ADDENDUM NO. 2

Norwalk Transit District Fuel Island, Service Lane and Tank Replacement 437404

Project No. 437404

DWG. TITLE **ELECTRICAL SCHEDULES**

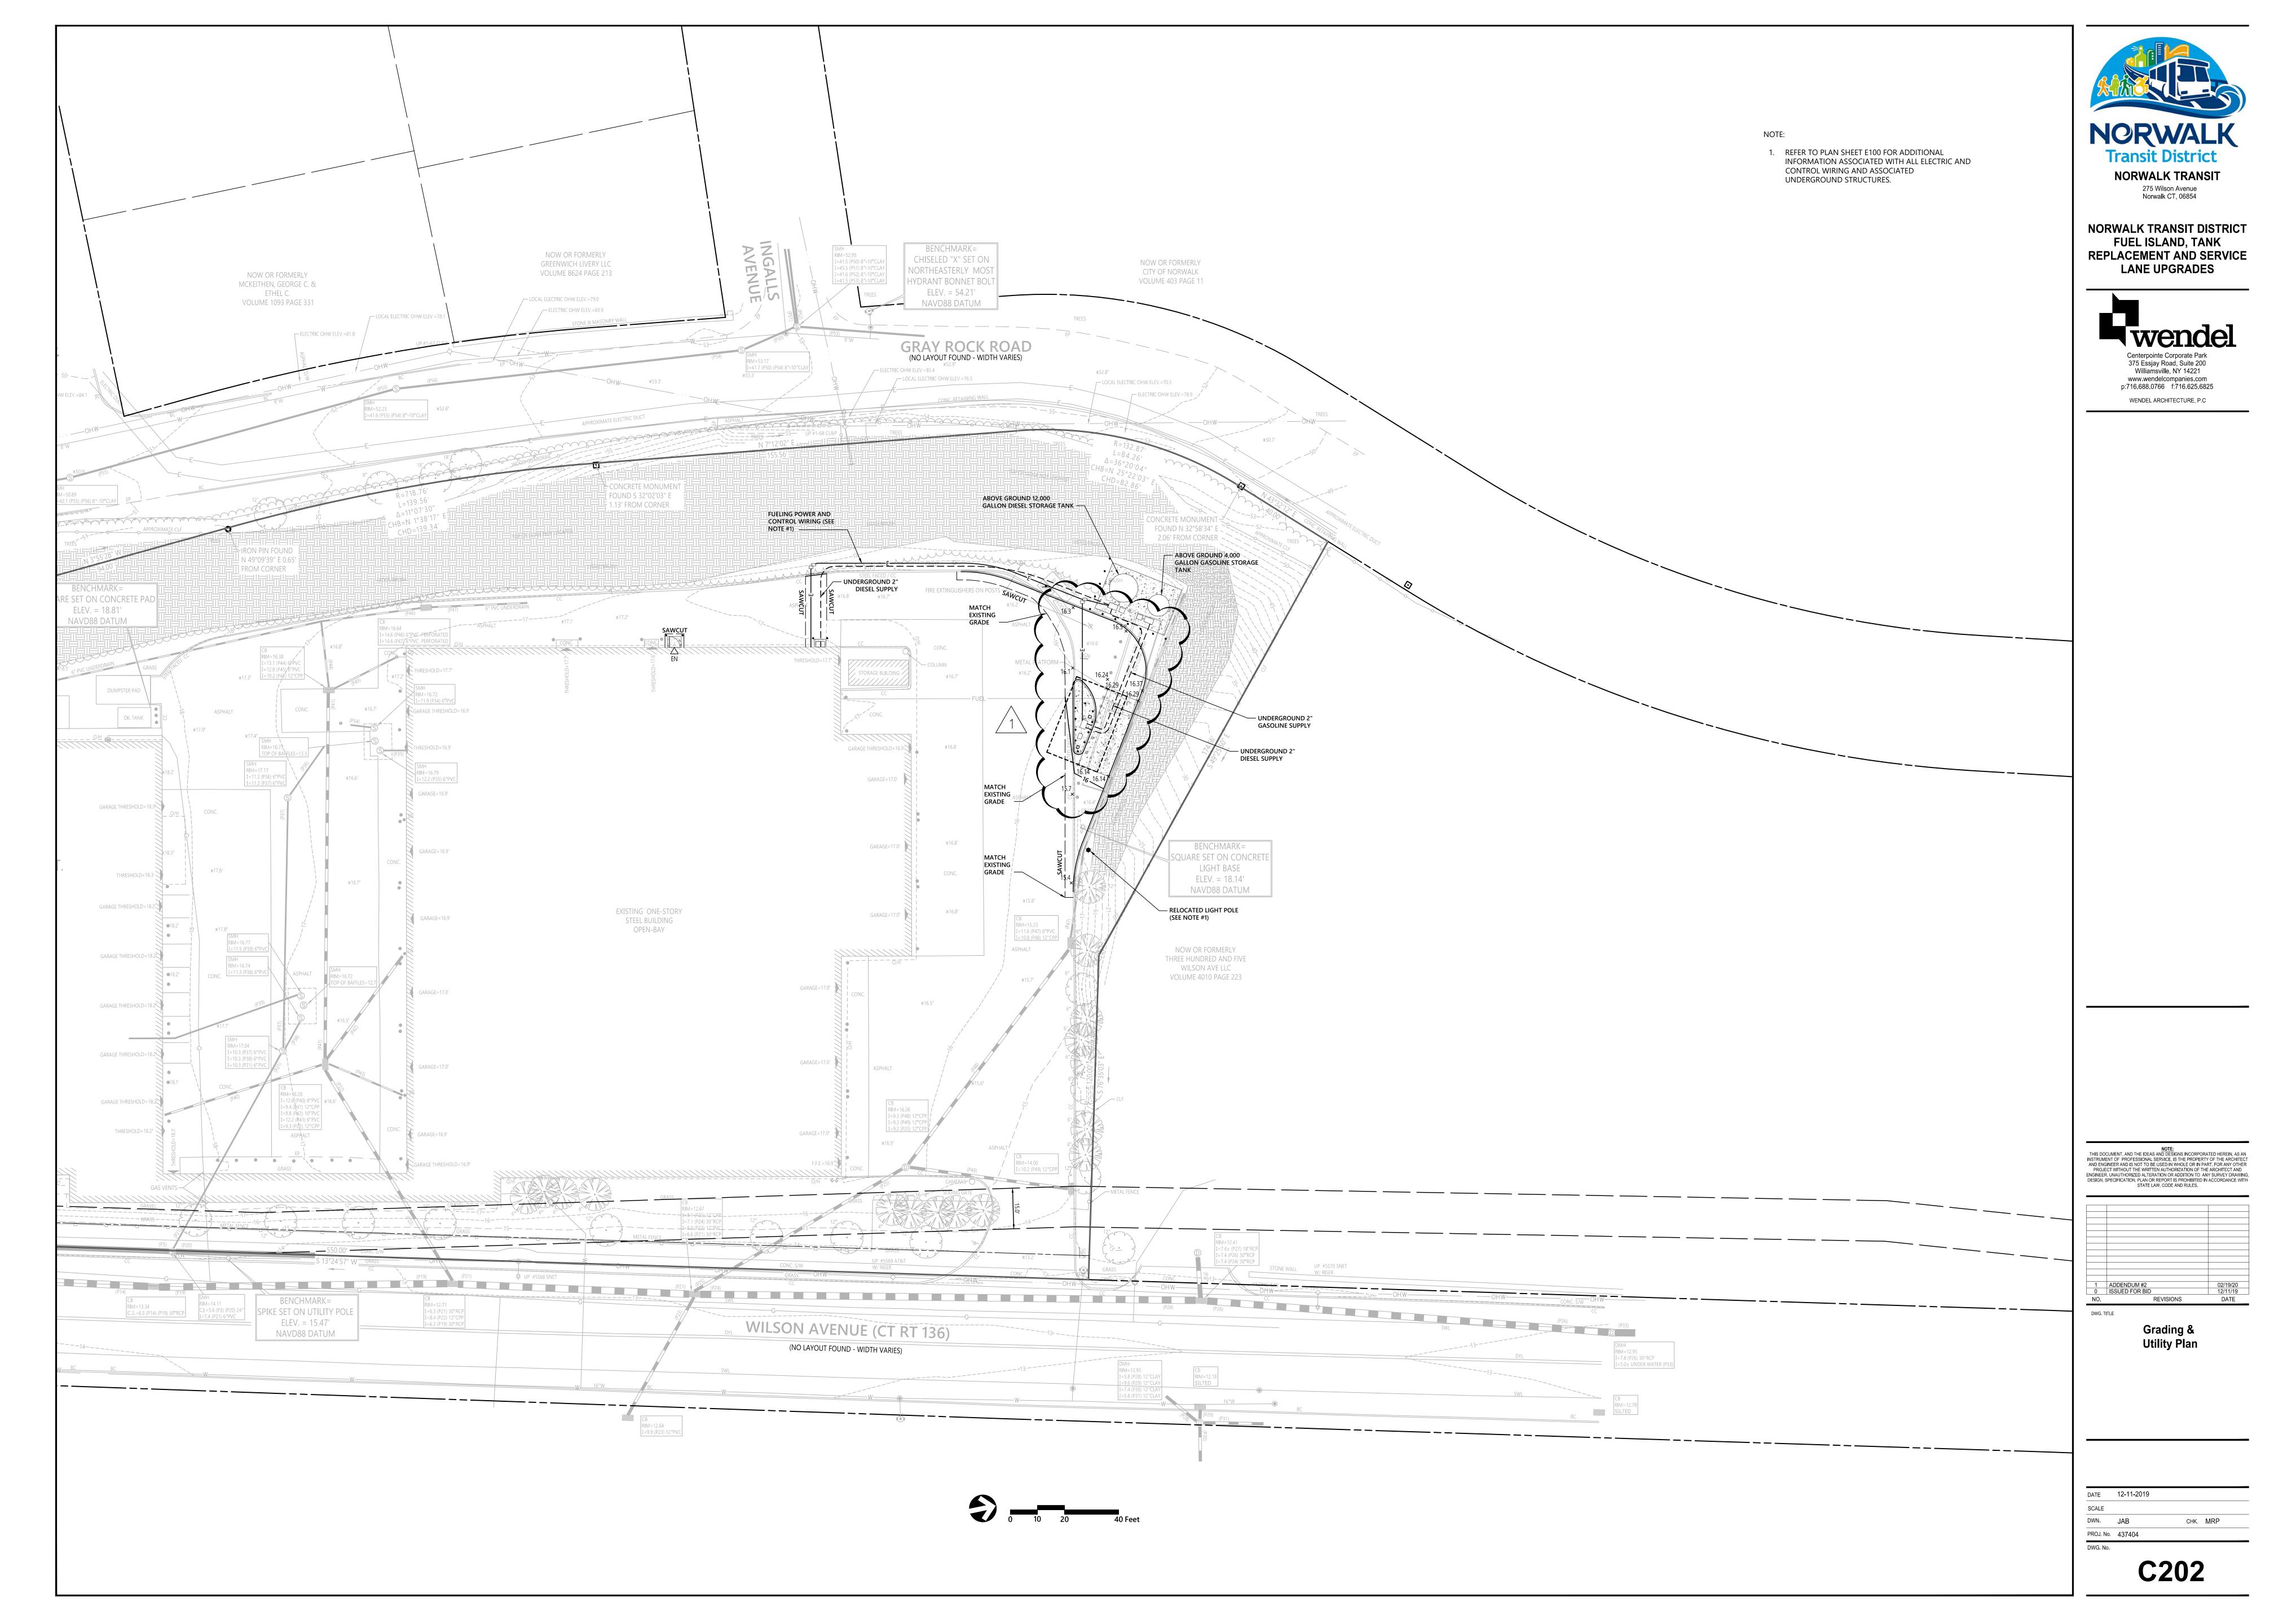
1 BID ADDENDUM #2 0 ISSUED FOR BID REVISIONS

- 2. PROVIDE NEW CIRCUIT BREAKER IN THE EXISTING PANELBOARD.
- 3. THE FOLLOWING CIRCUIT BREAKER IS PRESENTLY CONNECTED TO AN EXISTING FUELING SYSTEM EQUIPMENT, IT SHALL BE REMOVED ONCE THE EQUIPMENT HAS BEEN REMOVED. PROVIDE NEW 2 POLE 20 AMP CIRCUIT BREAKER FOR THE NEW OVERHEAD DOORS IN THE RESULTING SPACES, MODIFY CIRCUIT DIRECTORY ACCORDINGLY.
